REVISION #1 - 3/17/2025: FBEG

REVISION #2 - 6/4/2025: EKG

MIDPOINT MEADOWS
PHASE 1

CITY PROJECT NO. 15331
CONTRACT NO. 9538

15331		MADISON, WI		9538	
UTILITIES PLAN & PROFILE - MID TOWN ROAD EXISTING		MIDPOINT MEADOWS - PHASE 1		CONTRACT NO:

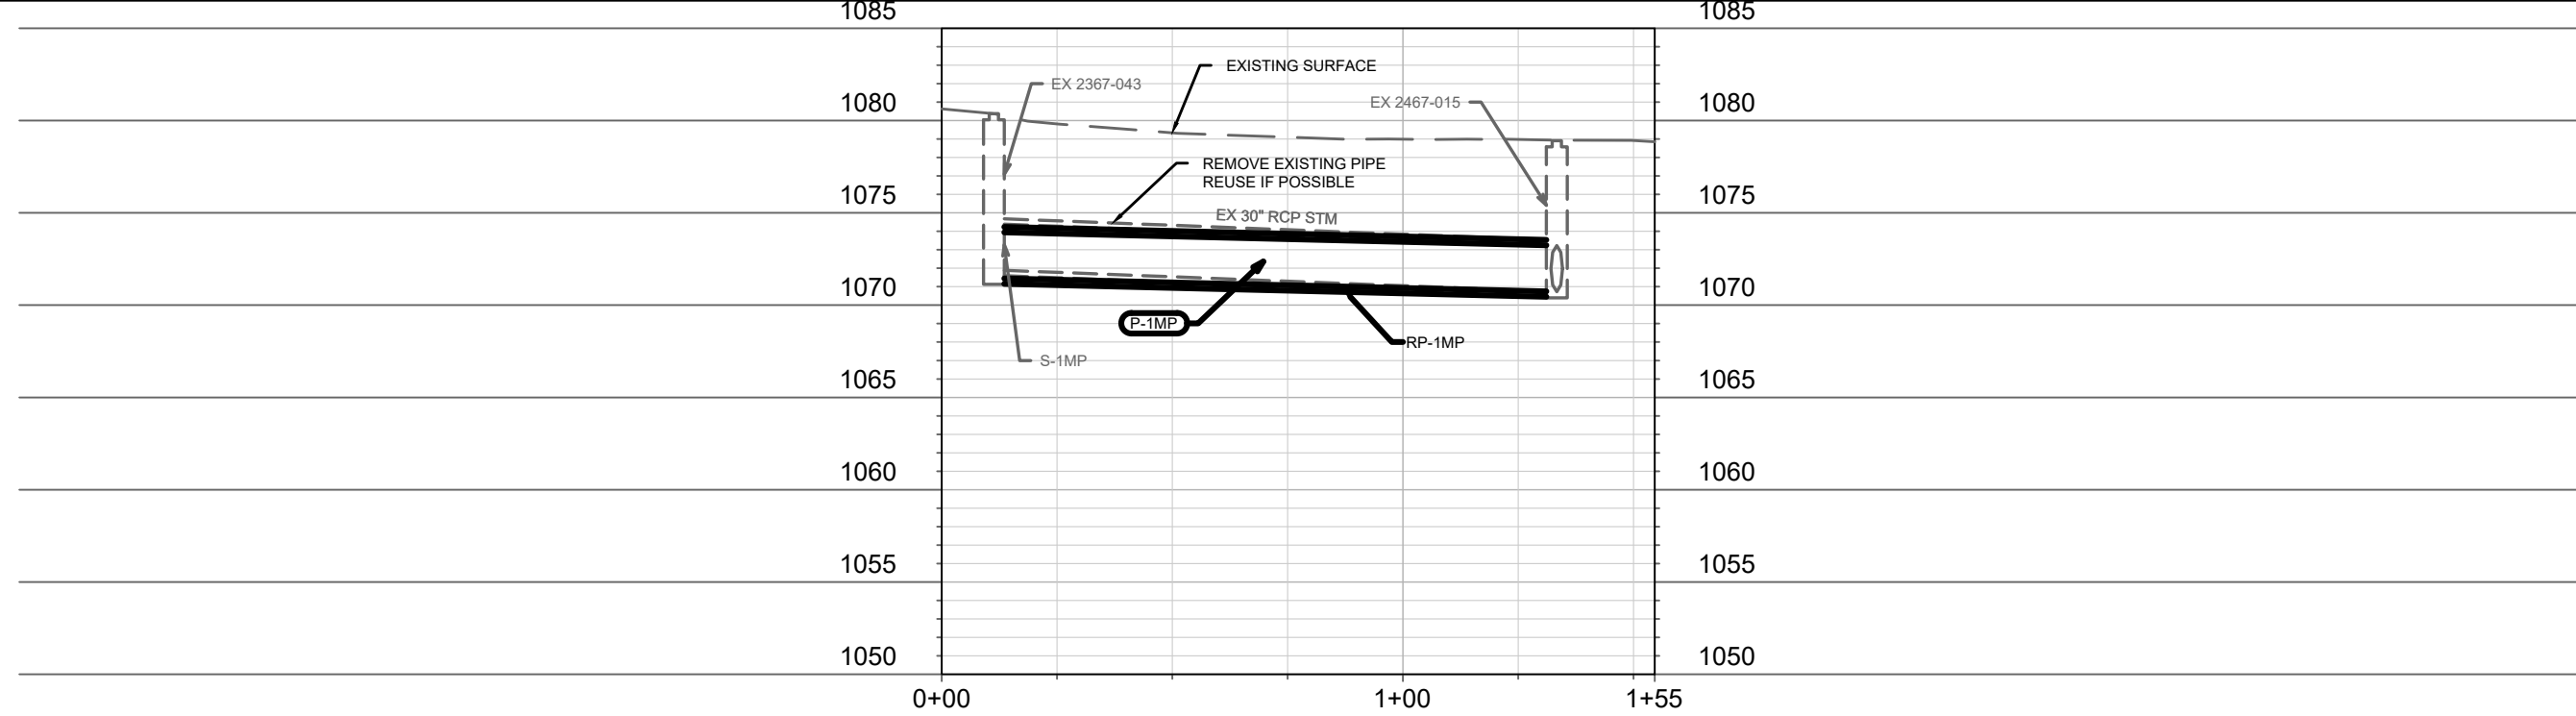
REVISION #2:
REMOVE & RELAY 30" STM PIPE AT MIDTOWN RD.
